To: T10 Technical Committee
From: Rob Elliott, HP (elliott@hp.com)
Date: 9 July 2006
Subject: 06-279r2 SAS-2 Allow more than one ZSDS in a SAS domain

Revision 0 (13 June 2006) First revision
Revision 1 (4 July 2006) Incorporated comments from 20 June 2006 SAS zoning WG. Updated to a base of sas2r04a.
Revision 2 (9 July 2006) Incorporated comments from 6 July 2006 SAS zoning WG.

Figure 1 — Two ZPSDSes introduction

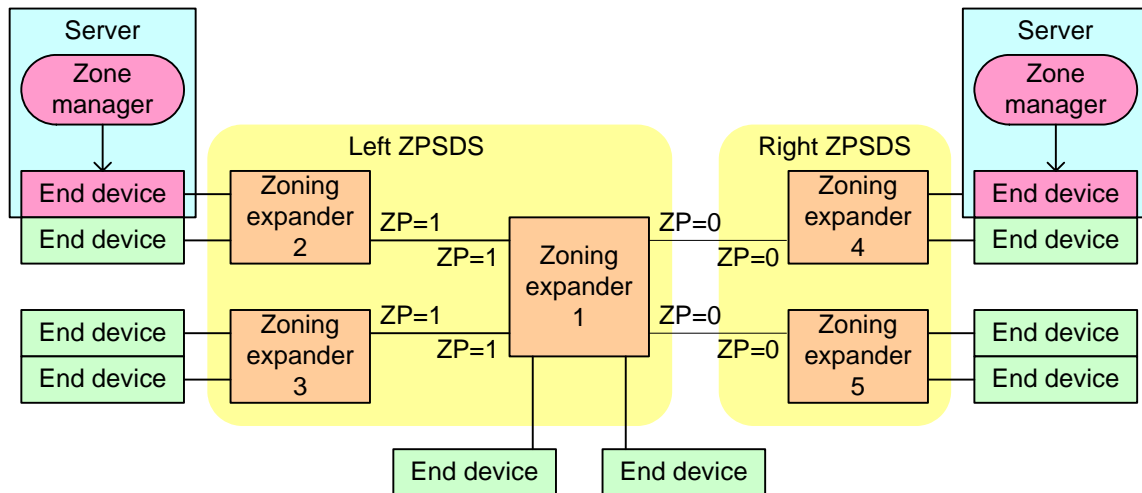
Figure 1 shows two ZPSDSes. As long as the ZONE PARTICIPATING bits are set to zero at the boundaries, they can coexist - devices on the left would not be able to talk to devices on the right (but all the devices can all see all the expanders, since expanders are in ZG 1).

Figure 3 — Zone manager location examples

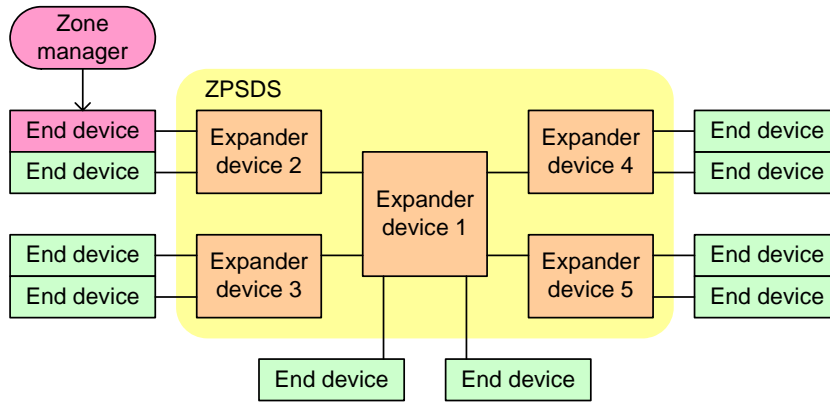
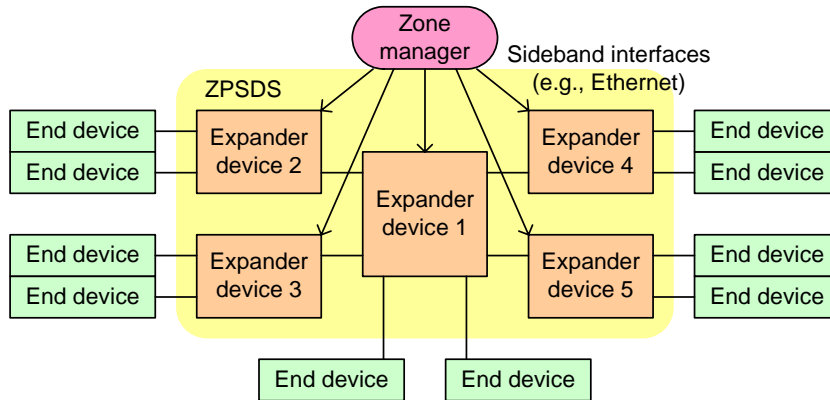
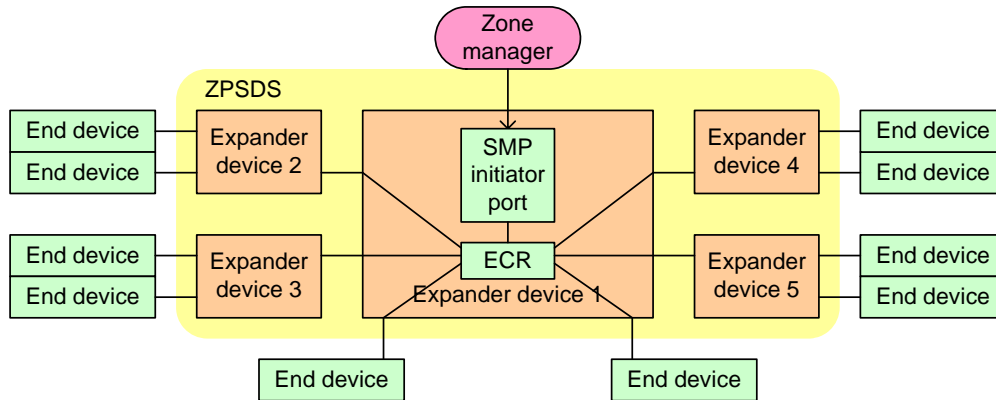
[A ZPSDS has a zone manager responsible for its configuration. The zone manager may have access to an end device with a SAS port whose zone group has access to zone group 2, or may have access to one or more zoning expander devices through a sideband interface \(e.g., Ethernet\) outside the scope of this standard.](#)

Figure 3 shows examples of zone manager locations in a SAS domain.

Figure 4 — Three ZPSDSes example

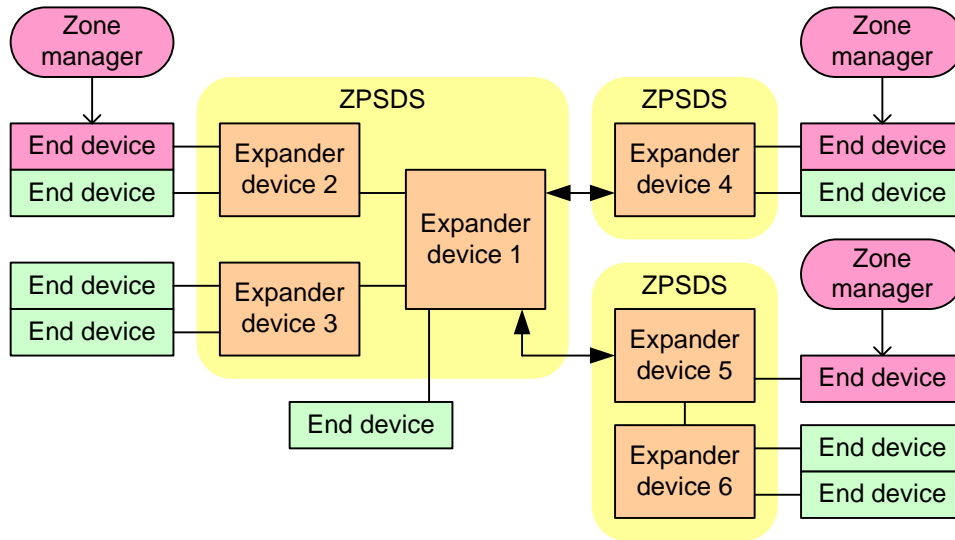
There shall be at most one may be any number of non-overlapping ZPSDSes in a service delivery subsystem, particularly as a SAS domain is being reconfigured (e.g., as a user is attaching enclosures together). The A ZPSDS may encompass some or all of the service delivery subsystem.

Figure 4 shows an example of three ZPSDSes in a SAS domain.

Figure 55 — Example of a ZPSDS with the ZONE ADDRESS RESOLVED bit set to zero updated to remove “Zoning” and “Non-zoning” prefixes in front of “expander device”

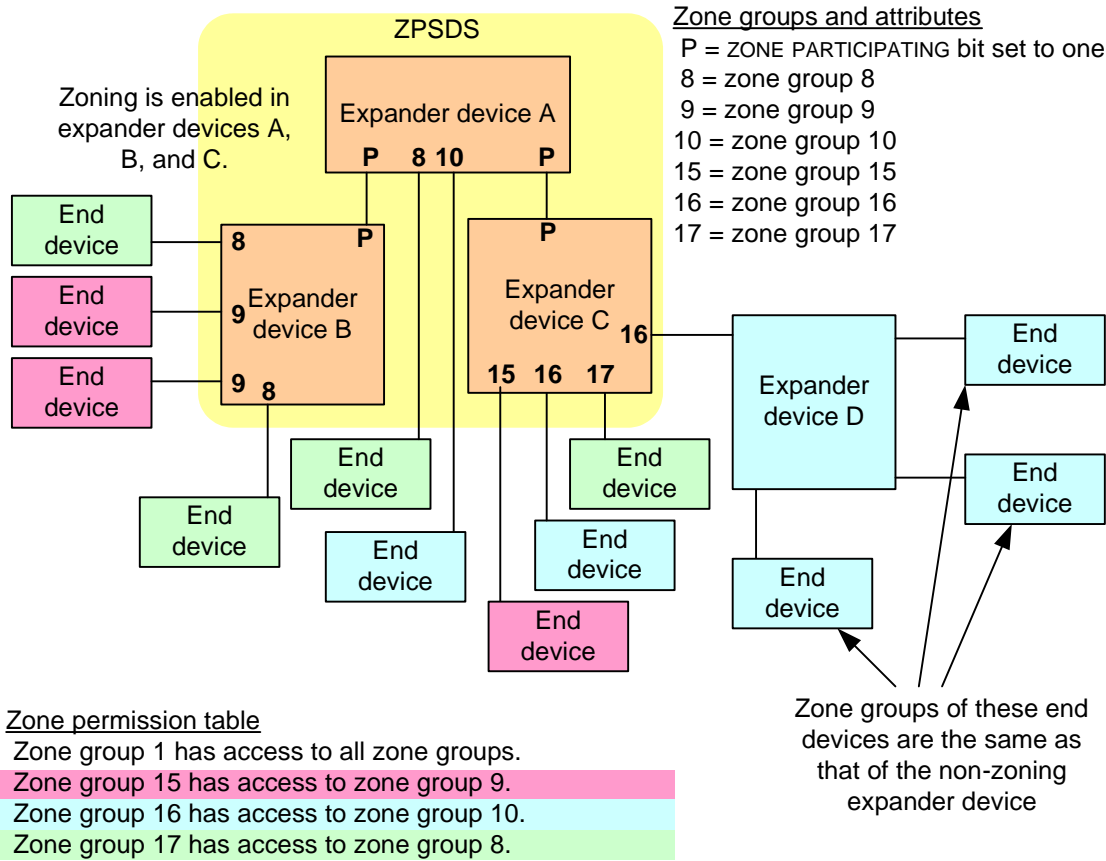
Editor's Note 3: the following text and figures were moved from 4.8.1.

Figure 55 shows an example of a ZPSDS in which the ZONE ADDRESS RESOLVED bit of the expander port of ~~zoning~~ expander device C that is attached to ~~non-zoning~~ expander device D is set to zero.

Figure 56 — Example of a ZPSDS with the ZONE ADDRESS RESOLVED bit set to one updated to remove “Zoning” and “Non-zoning” prefixes in front of “expander device”

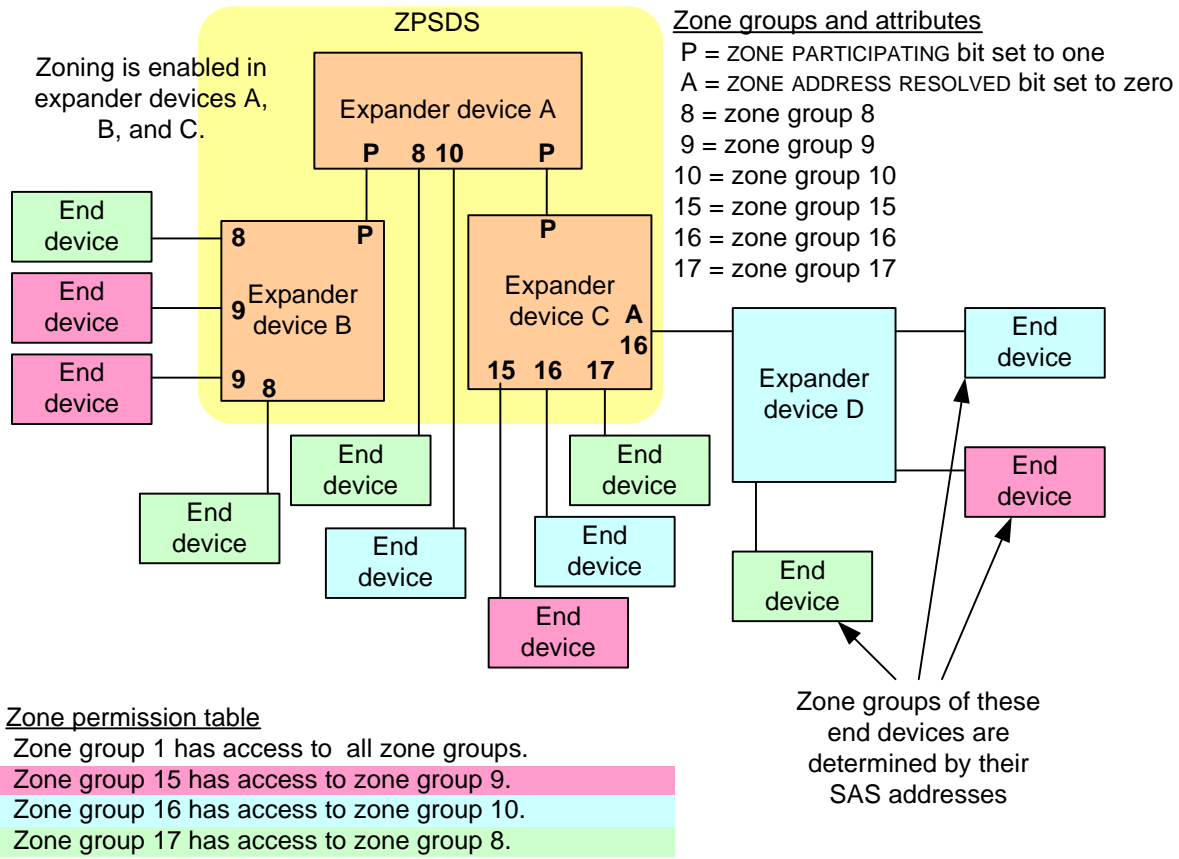
Figure 56 shows an example of a ZPSDS in which the ZONE ADDRESS RESOLVED bit of the expander port of ~~zoning~~ expander device C that is attached to ~~non-zoning~~ expander device D is set to one.
